Notice of Meeting Polk City | Planning and Zoning Commission (P&Z) *********

May 17, 2021 | 6:00 pm City Hall | Electronic Meeting **Due to Covid-19 the P&Z Commission will meet in person with Public Meeting participation via phone only Call in local 515-329-8019 Participant Code 593054 Public can provide comments directly to support**

PRELIMINARY PLAT REVIEW

Date:May 14, 2021Project:Big Creek Commons

P.U.D MASTER PLAN 117 E. BROADWAY Sheet 1 of 1

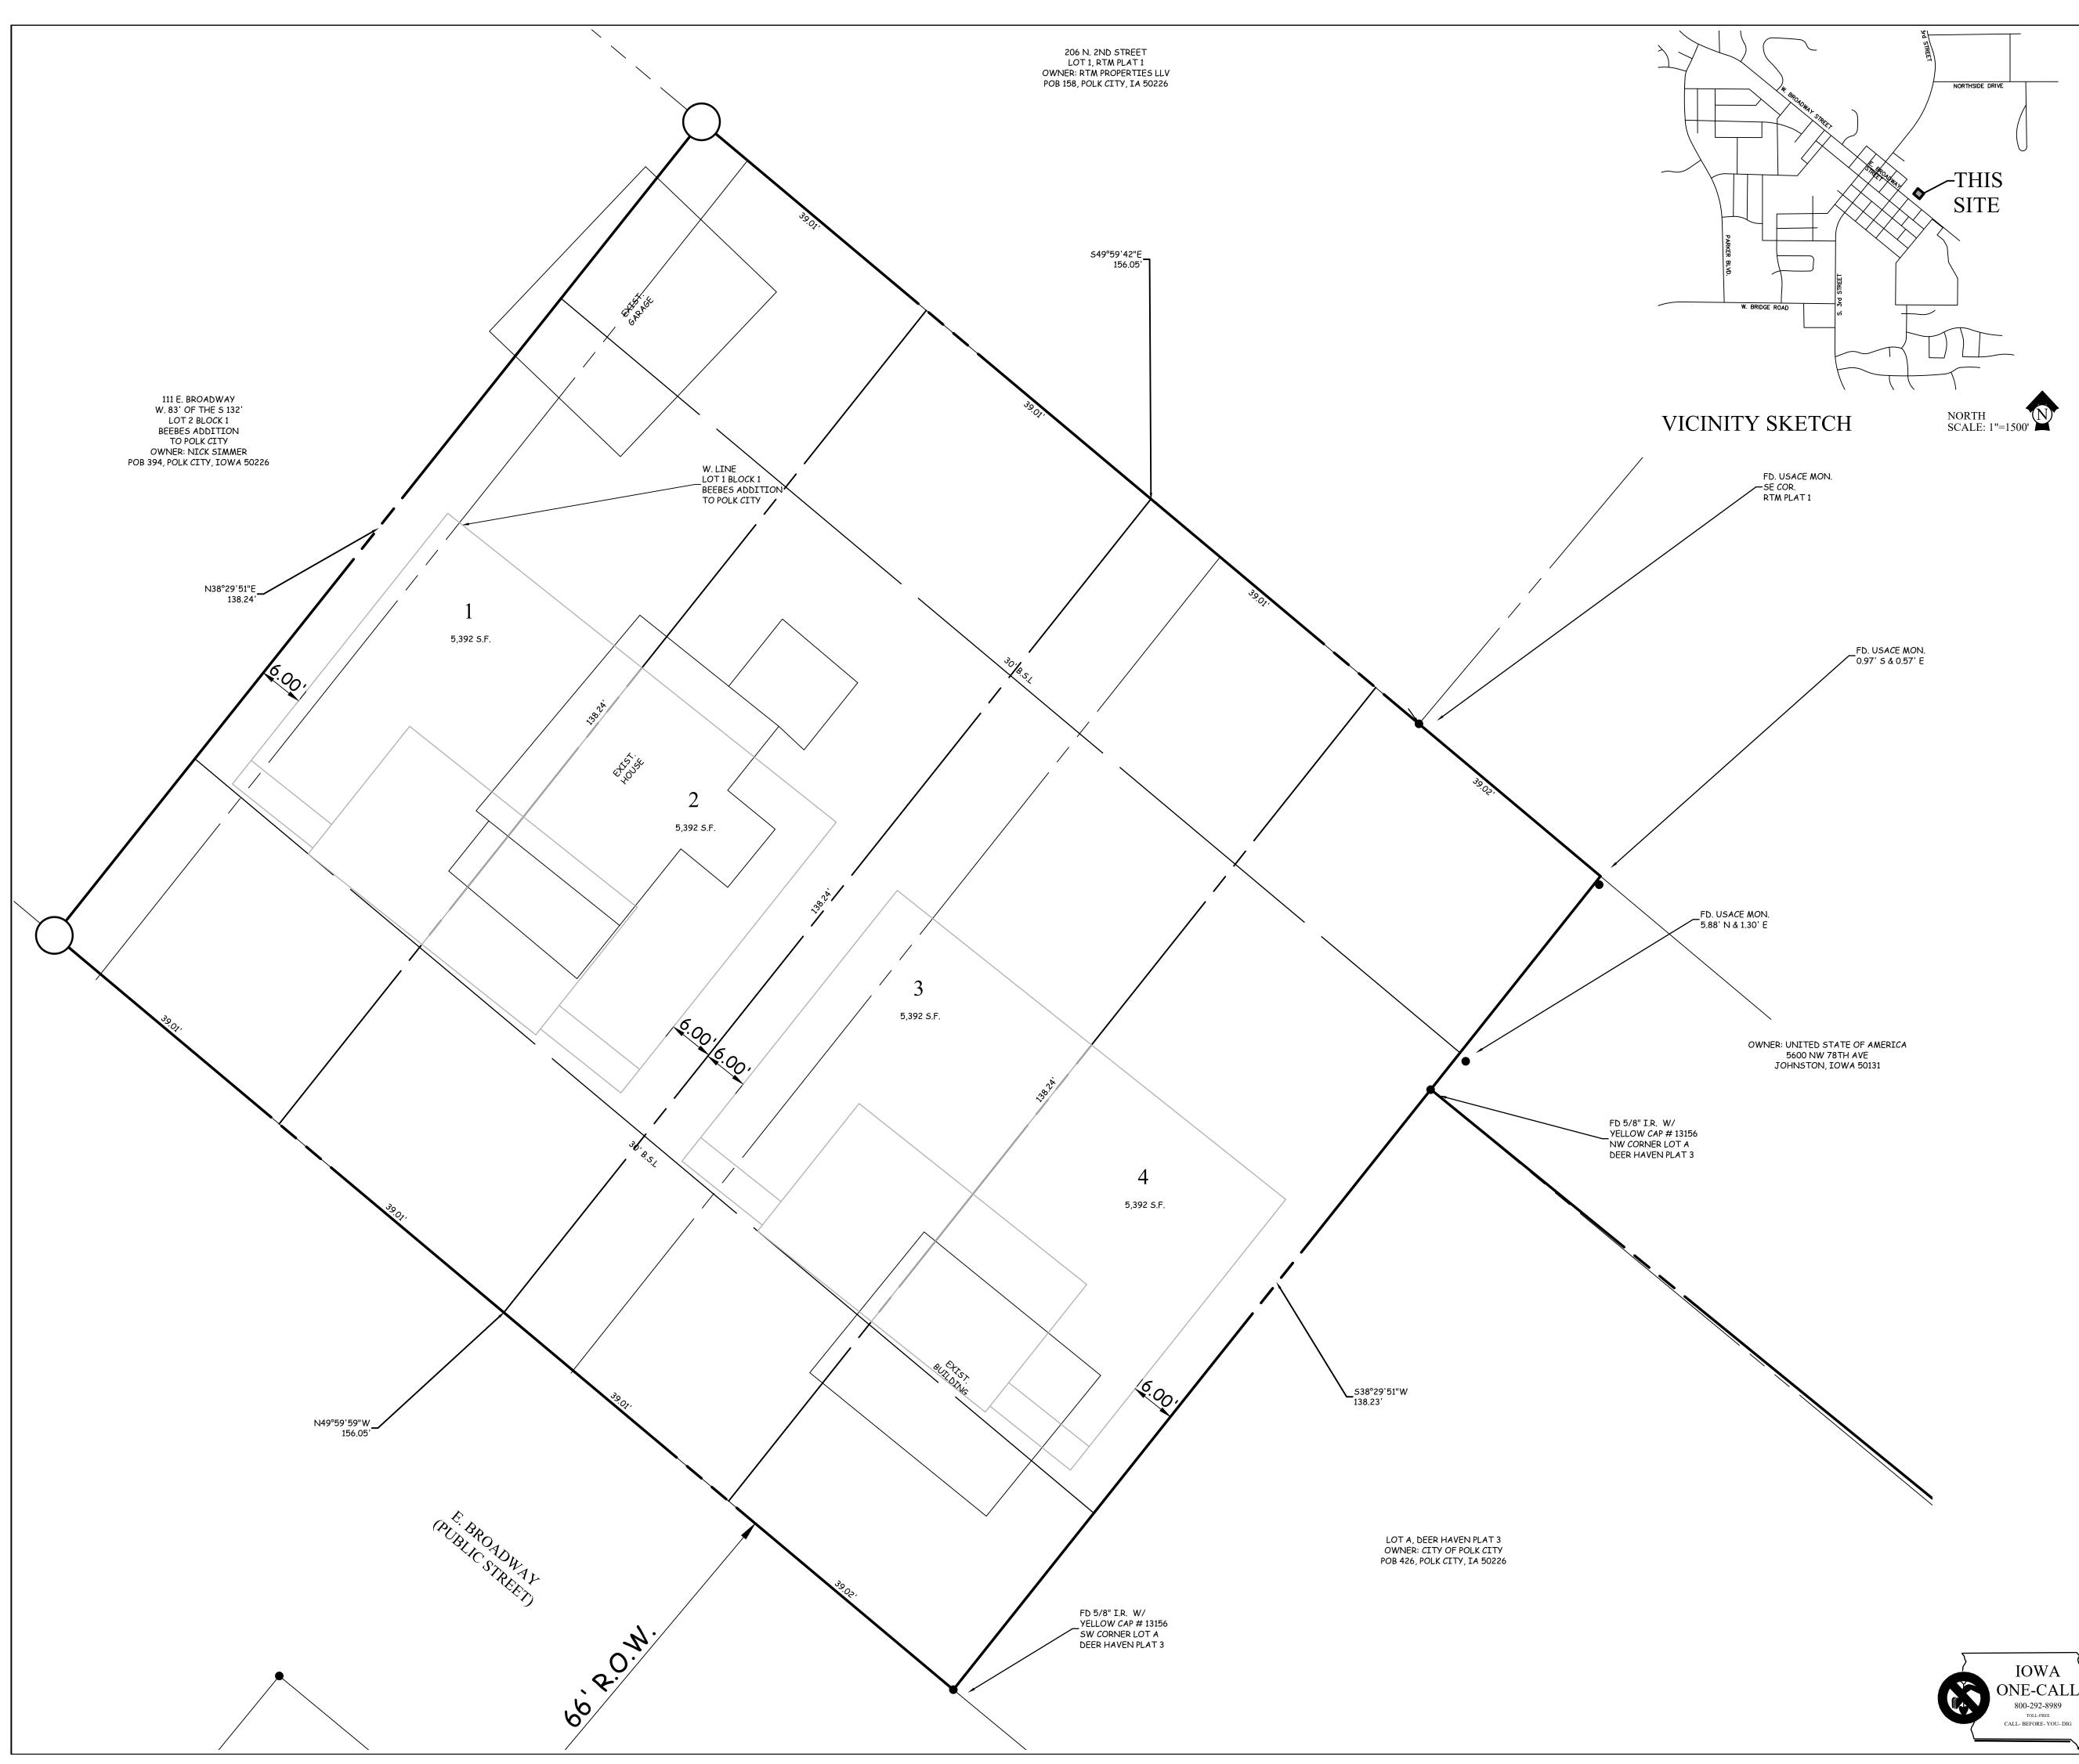
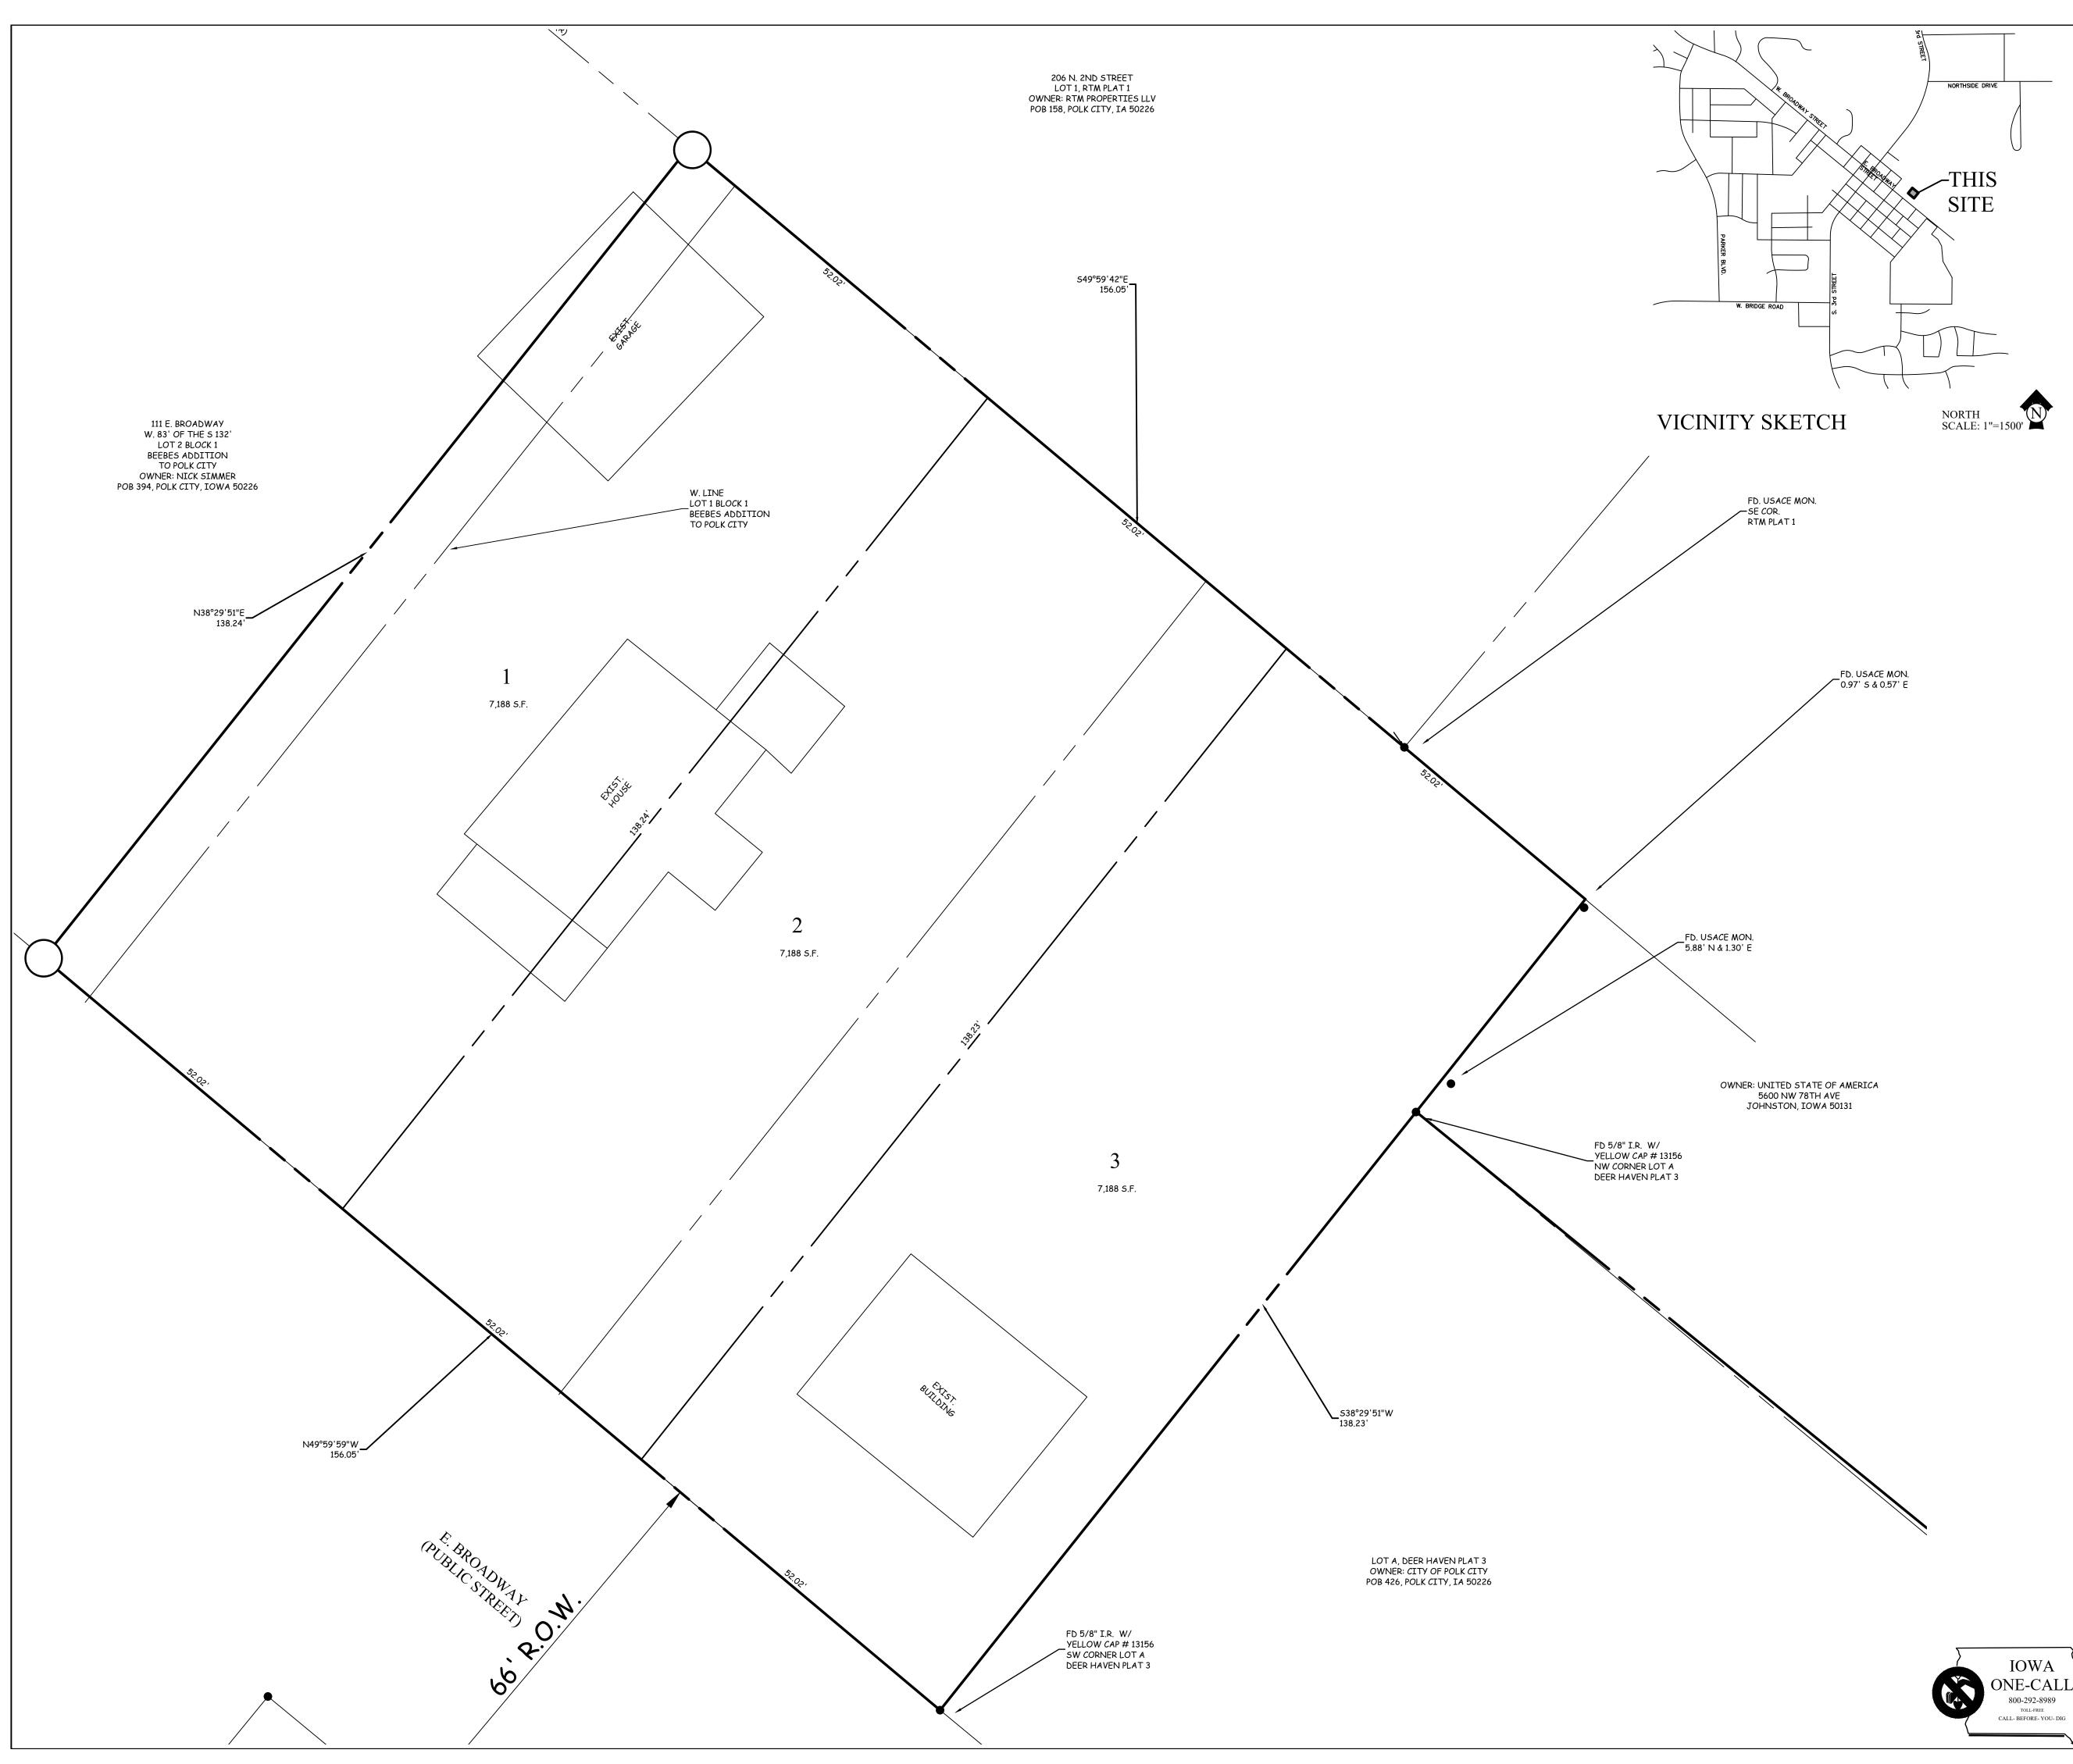
Pursuant to our review of Submittal #2 of the proposed PUD Master Plan, we offer the following comments.

- 1. We understand the driveway serving 111 E. Broadway may encroach into the northwest portion of this development. This issue will be reviewed in more detail on the preliminary plat. However, this is a private issue between two private property owners, but must be considered when siting the home and driveway on Lot 1 to be sure the established setbacks can be met at the time of Building Permit application.
- 2. This property will need to be platted in order to subdivide the property. At the time of preliminary platting, we will review issues such as proposed driveway locations; 10' wide trail with crosswalk; hydrant coverage and potential need for a fire hydrant; the developer/homebuilder's responsibility to install water services and sanitary sewer services to each lot, including boring under the newly paved streets; French drain pits for sump discharge; and sidewalks.

- A. Approve the applicant's request to amend the Comprehensive Plan to designate their property as low density residential and rezone their property to Planned Unit Development (PUD) as presented, including the following PUD restrictions:

- a. This property shall be platted in accordance with the Subdivision Regulations prior to issuance of a Building Permit for any new buildings on this property.

- b. Use of this property shall be restricted to single-family detached or single-family bi-attached residential uses only.
 - c. Minimum lot width shall be 52 feet square feet for single-family homes and 39 feet for each dwelling unit for bi-attached homes.

- d. Minimum lot size shall be 6,400 square feet for single-family homes and 5,000 square feet for each dwelling unit for bi-attached homes.
 - e. Bi-attached dwellings shall have one shared driveway per two-family structure, each with a maximum width of 30 feet.

- f. Minimum setbacks for all uses shall be 30' front yard, 6' side yard, and 30' rear yard.
 - g. A 10-feet wide recreational trail shall be constructed along E. Broadway in front of all lots in this subdivision, with a 4-feet wide ADA crosswalk on the southeast side of Summer Street.
